SUBJECT: COMANCHE PEAK NUCLEAR POWER PLANT, UNITS 3 AND 4
DOCKET NUMBERS 52-034 AND 52-035
RESPONSES TO REQUESTS FOR ADDITIONAL INFORMATION NO. 2577 AND 2581

Response to Request for Additional Information No. 2577 (CP RAI #24)

RAI NO.: 2577 (CP RAI #24)

SRP SECTION: 08.02 – OFFSITE POWER SYSTEM

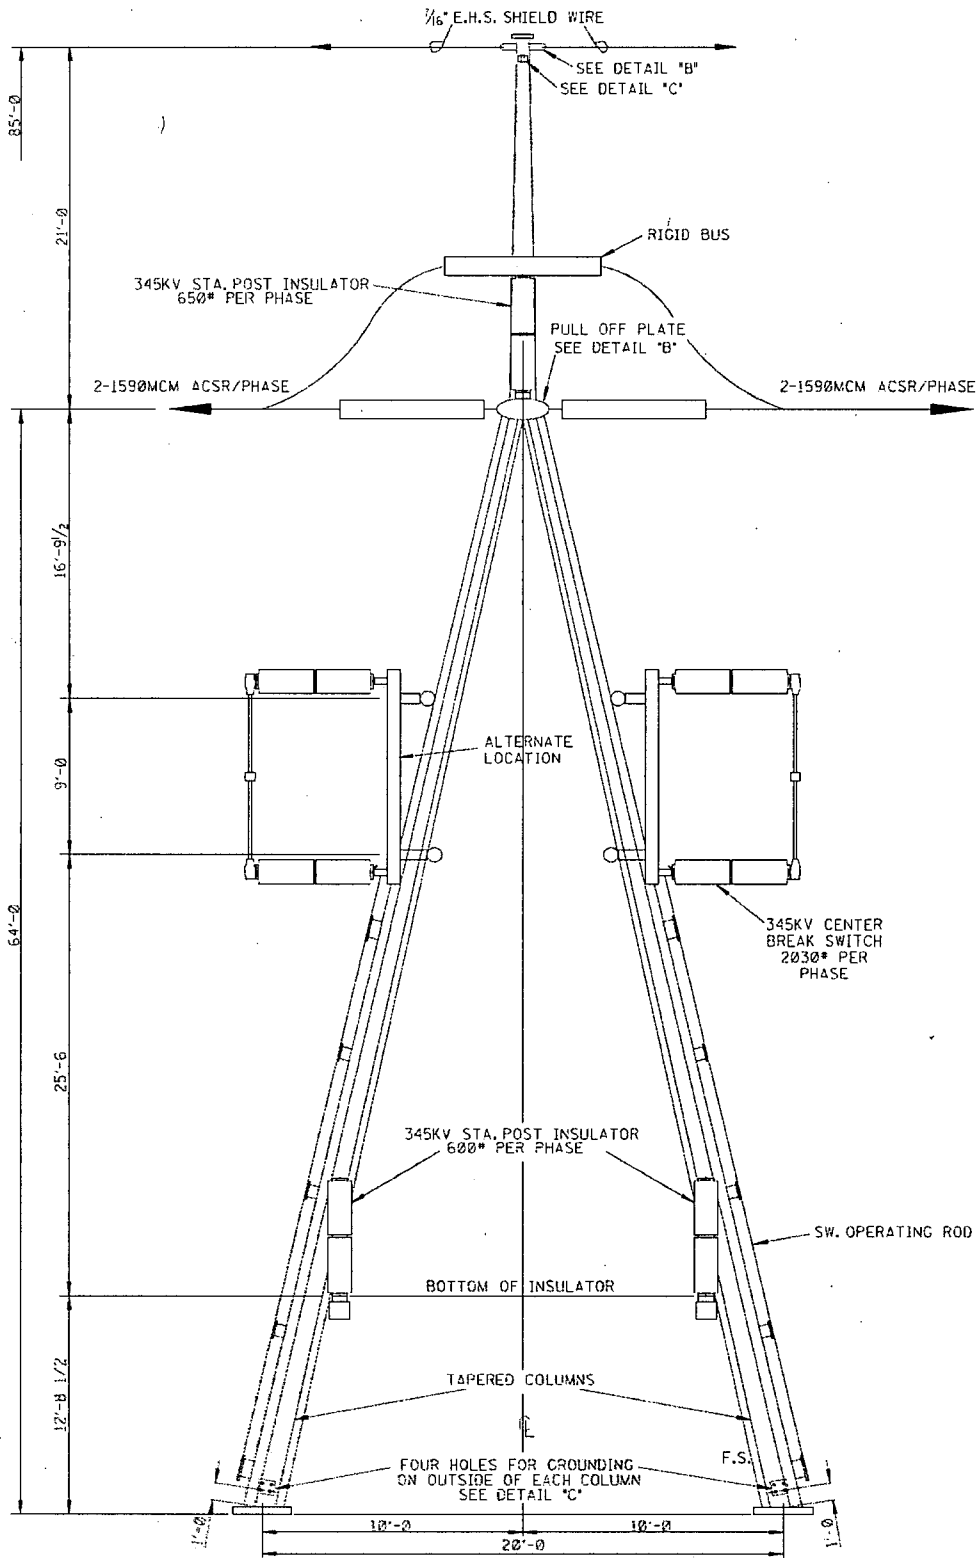
FSAR Subsection 8.2.1.2.1.1, Plant Switching Station, discusses the "fly-over" of existing circuit. Provide a physical layout of the installation showing the double dead-ending of these circuits.

FSAR Figure 8.2-206 is the physical layout of the plant switching station and depicts the plan view of the 345kV and 138kV double dead-end structures for the three (3) transmission circuits passing through the switching station (Parker, Comanche Switch, and Stephenville). The figure attached to this response is a typical elevation view of the double dead-end structures.

Attached Oncon Drawing E-67760-001 Sheet # 2 represents a typical Relay Functional Diagram of an outgoing transmission line from the plant switching station (Note – the Relay Functional Diagram does not show the physical location of components).

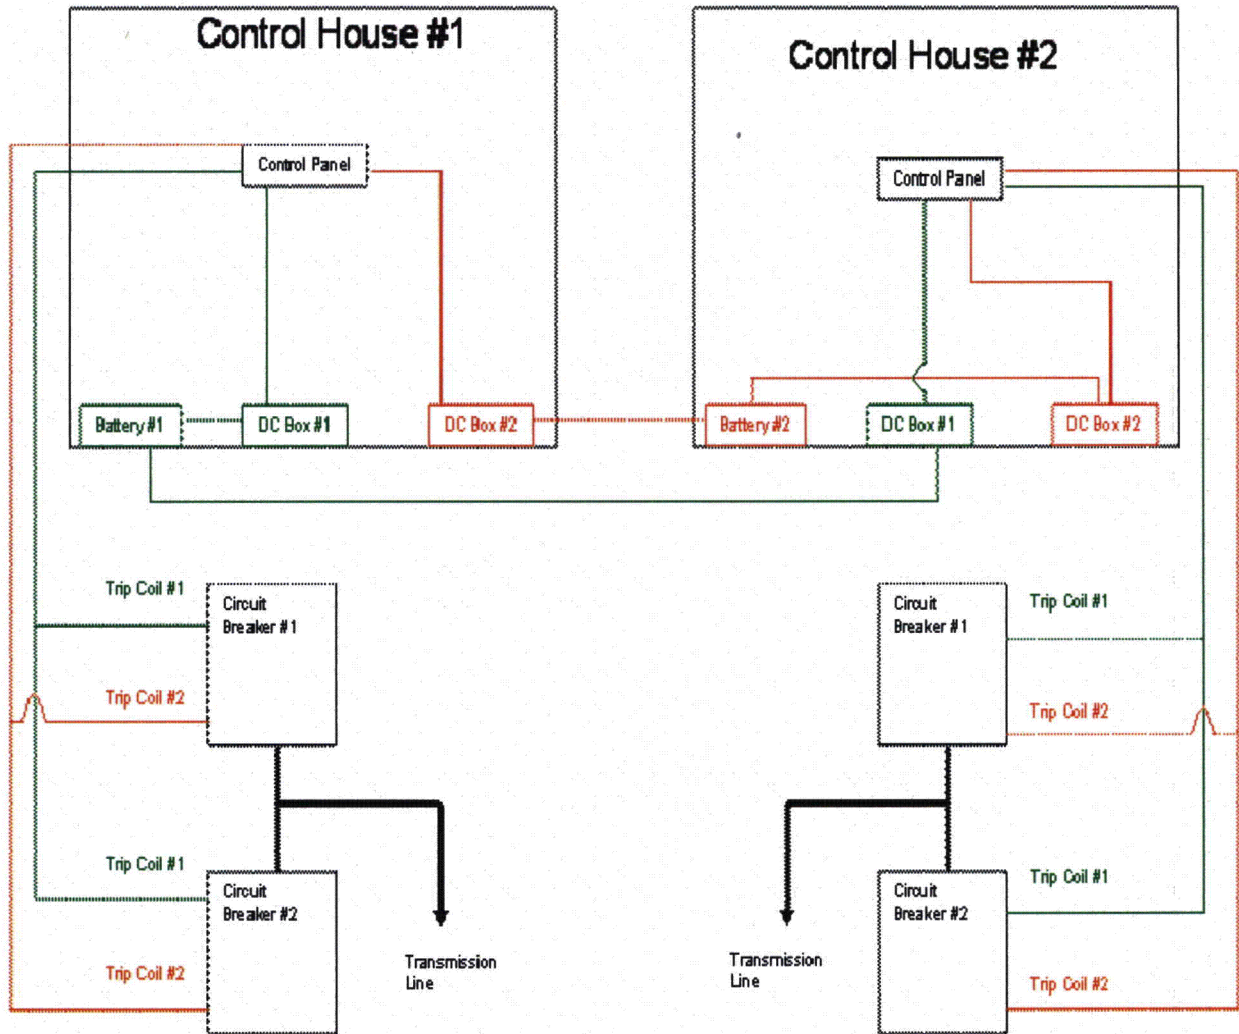
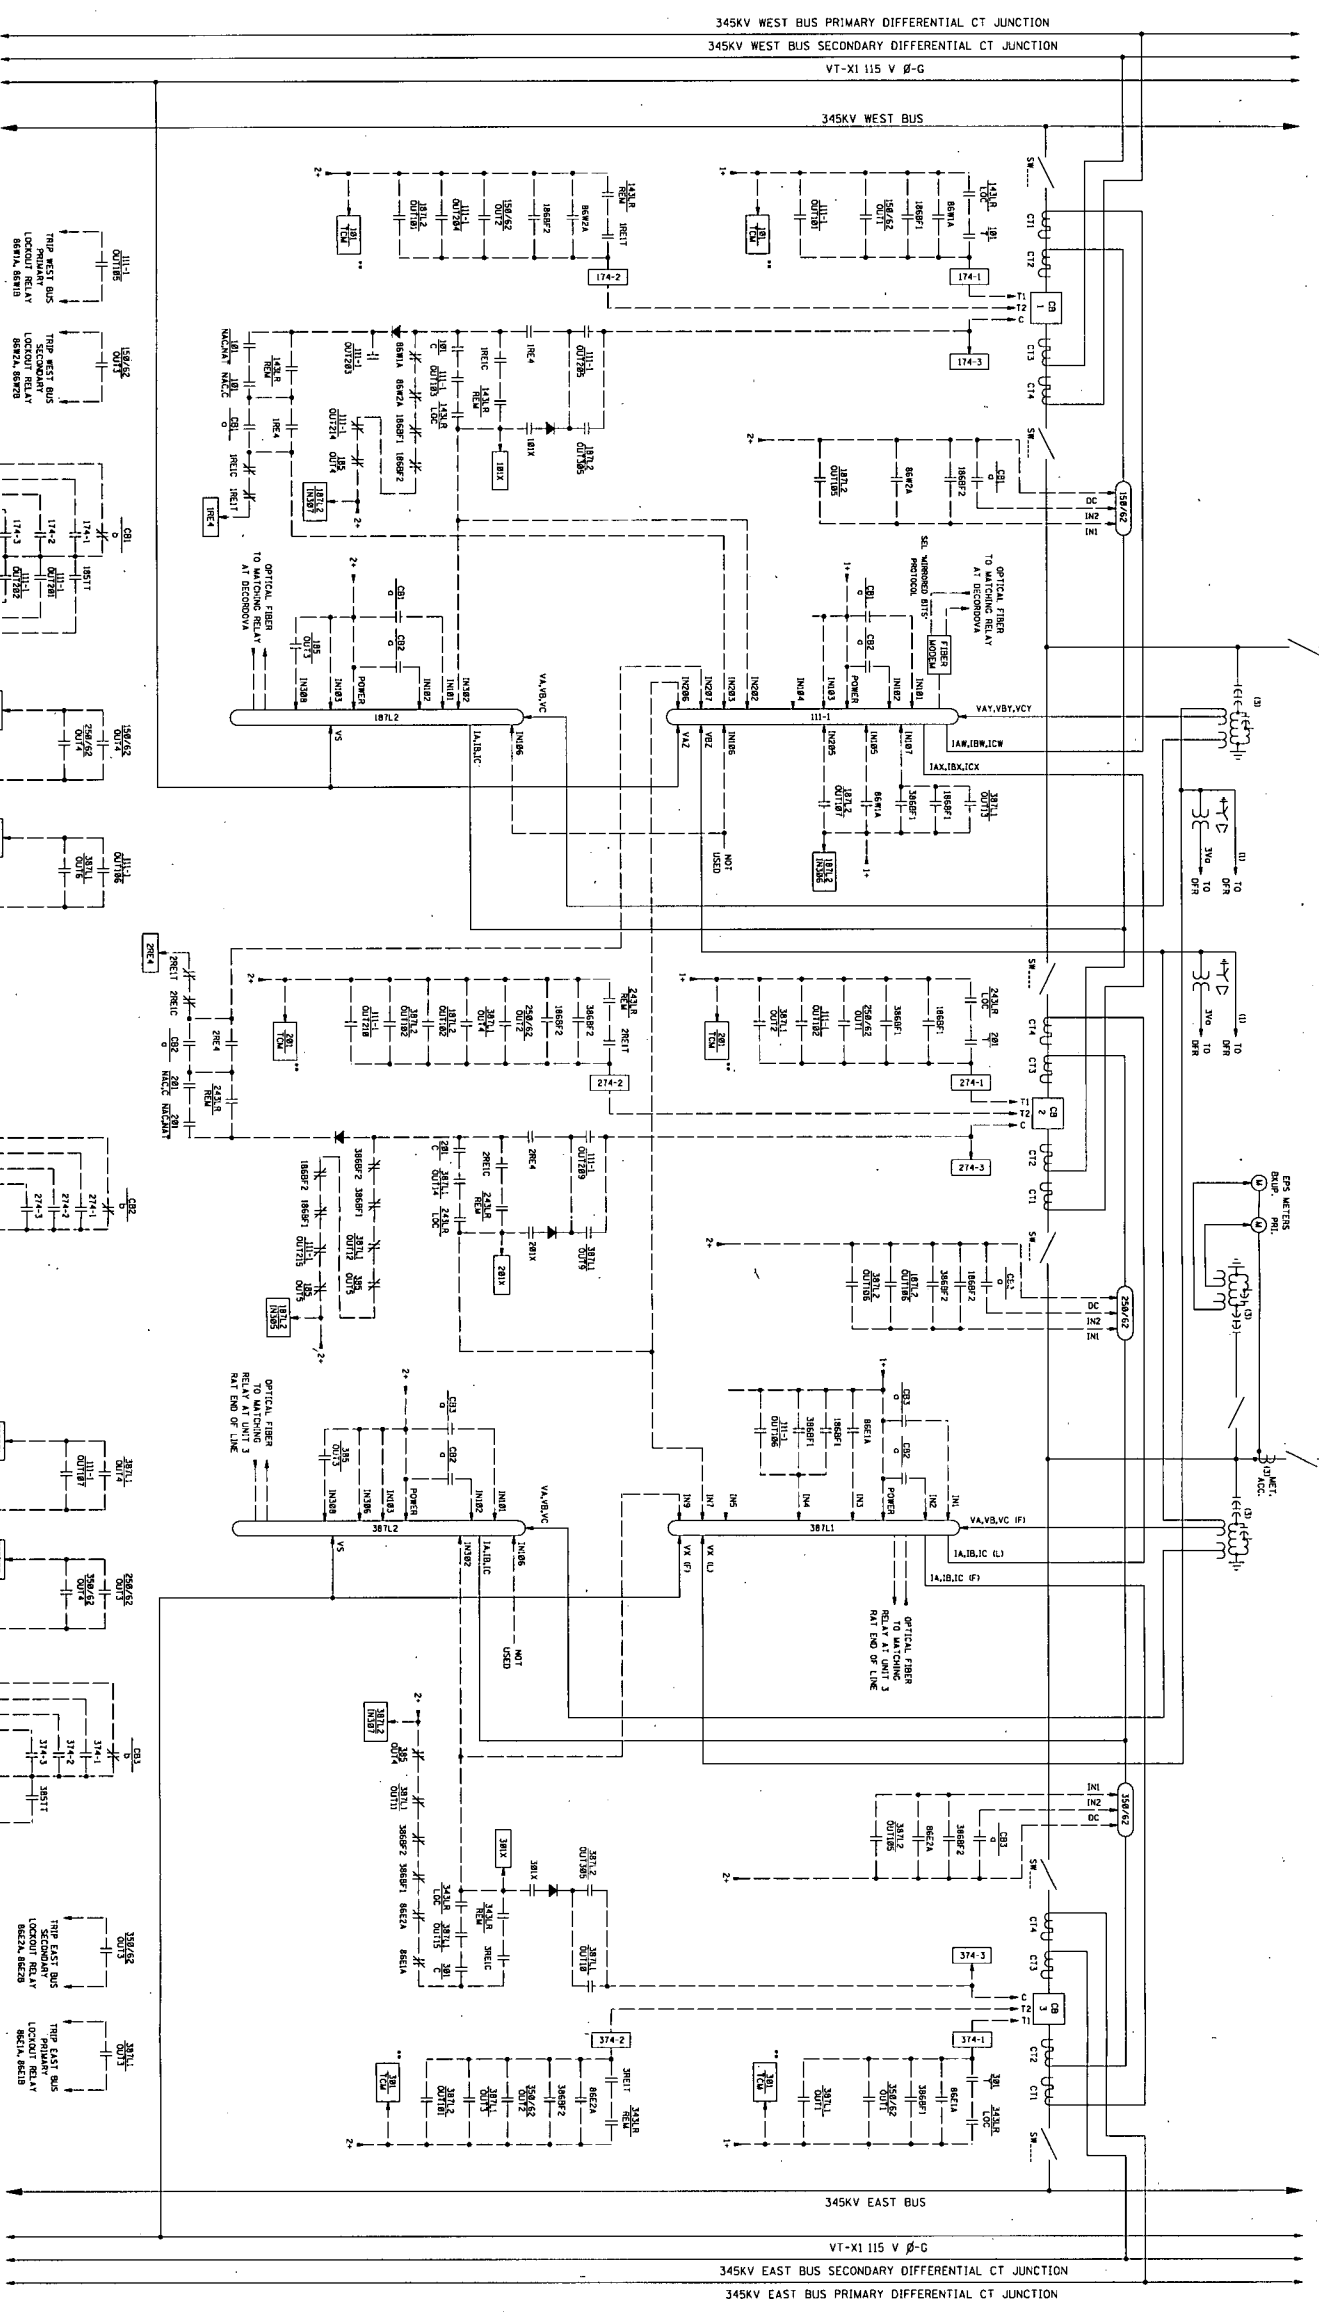
FSAR Subsection 8.2.1.2.1.1, Plant Switching Station, states that: "To reduce the cable lengths of the dc supplies in one control building to panels in the other control building, a set of fused cables are brought from the dc source in each control building to the dc box in the relay panel room of the other control building." Describe the control sources in this subsection and the location of the control and protection equipment in subsection 8.2.1.2, and explain how the protection scheme for each line is physically wired. Please also explain whether the failure of one control house, for any reason, will assure that either the primary or the backup protection system will operate to isolate a fault. Clarify the physical design and provide a wiring diagram of the two breakers associated with the same transmission line showing physical location of components.

Refer to the diagram below for the control source configuration for primary and back-up relay protections.
